LEVEL 0 - cycle access

date: 2019 09 06 - Rev A updated to reflect comments recived. increased door widths
date: 2019 08 30 - first issue

LEVEL B - internal cycle store

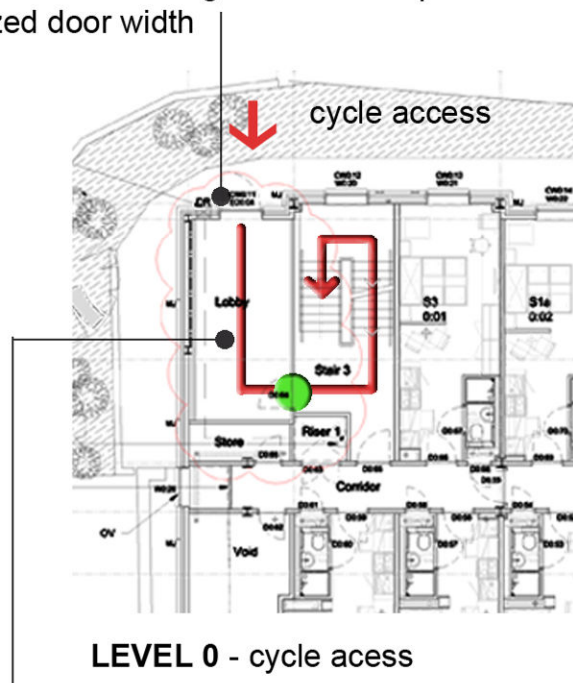
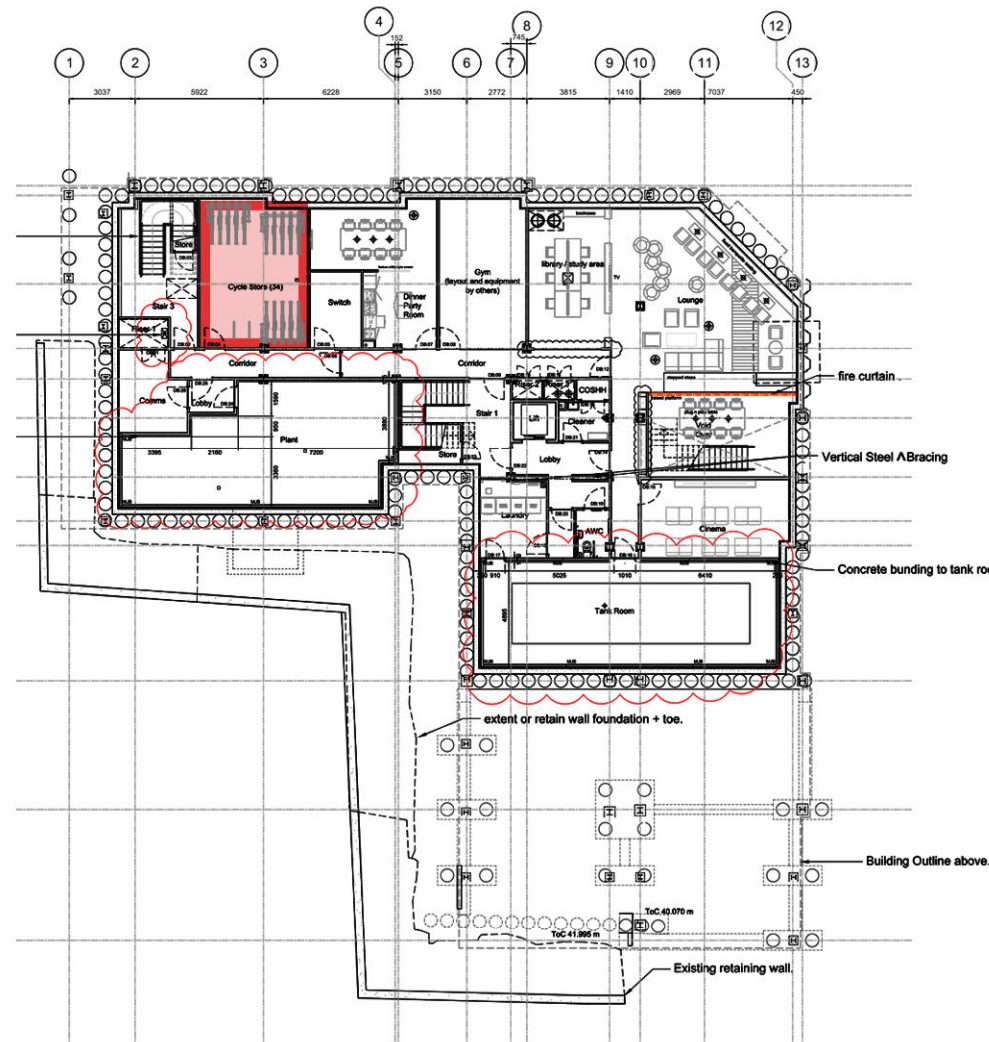
external door on access control with students would be able to access using their door swipe card.
oversized door width

lobby to have heavy duty matting to minimise dirt / wet through stair

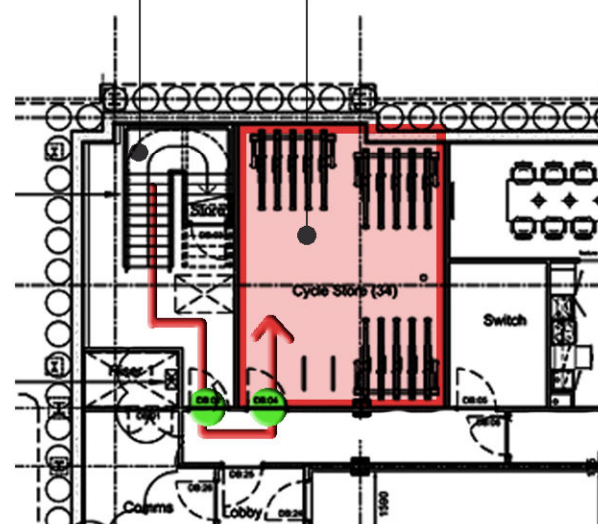
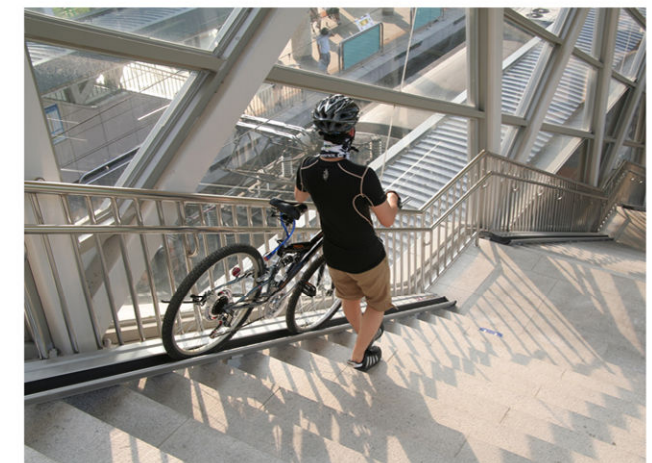
staircase to accommodate cycle rail
cycle storage location

3no. doors increased in size to allow for 893mm clear opening (1026mm leaf door)

staircase to accommodate cycle rail

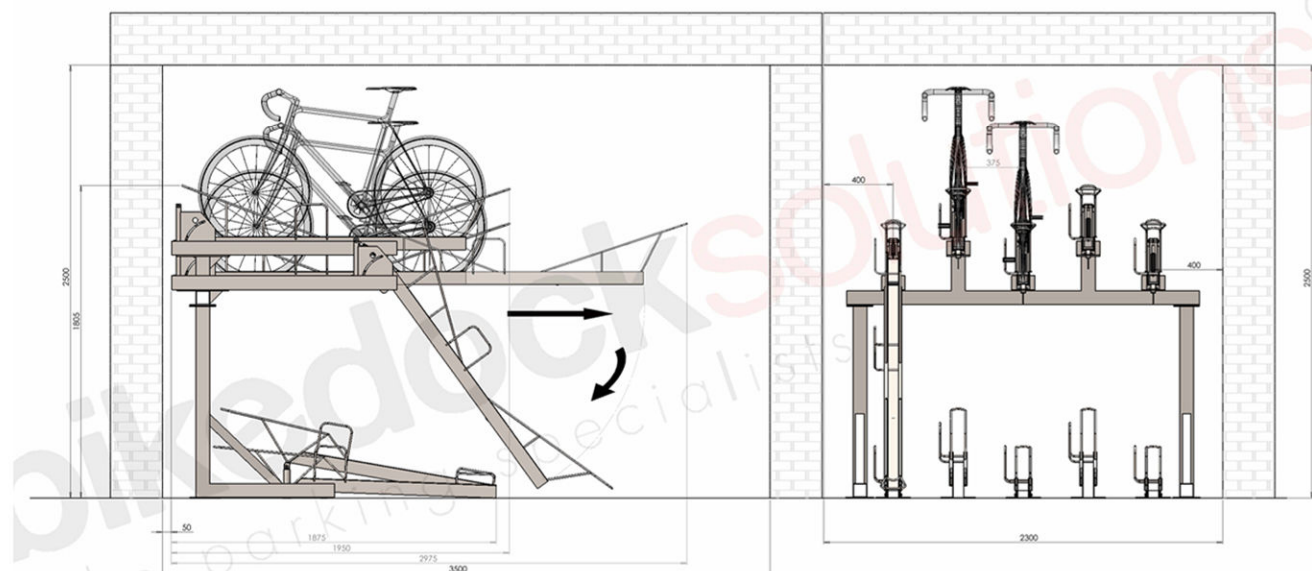
double tier cycle dock unit

cycle store accommodates 3no. double tier cycle dock units and 2no. hoops
